# UNITED STATES PATENT AND TRADEMARK OFFICE

APPLICATION NO.	FILING DATE	FIRST NAMED INVENTOR	ATTORNEY DOCKET NO.	CONFIRMATION NO.
10/657,938	09/09/2003	James Robert Champion	FOM-139.01	1614

<b>Office Action Summary</b>	<b>Application No.</b>	<b>Applicant(s)</b>	
	10/657,938	CHAMPION ET AL.	
	<b>Examiner</b>	<b>Art Unit</b>	
	Walter Benson	2858

**FINAL ACTION**

FIG. 3

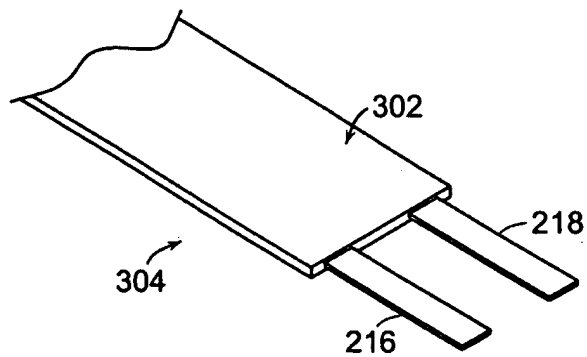
conductive element". Hence, the first and second conductor, being in physical proximity to each other, without further shielding element disclosed (figure 3) form an approximation to a transmission line with respect to each other. Because of this, a signal applied to one of the conductors will also drive the second conductor. Evidence of this assertion is presented in "the ARRL Handbook for Radio Amateurs", PTO 1449, filed 8/12/05, which presents a model a two conductor transmission line at page 16-1, figure 2. From this figure, it is evident that through capacitive and inductive coupling, each of the two conductors are inextricably linked. Thus, without some undisclosed measures, it is not possible to drive one of the conductors without driving the other.
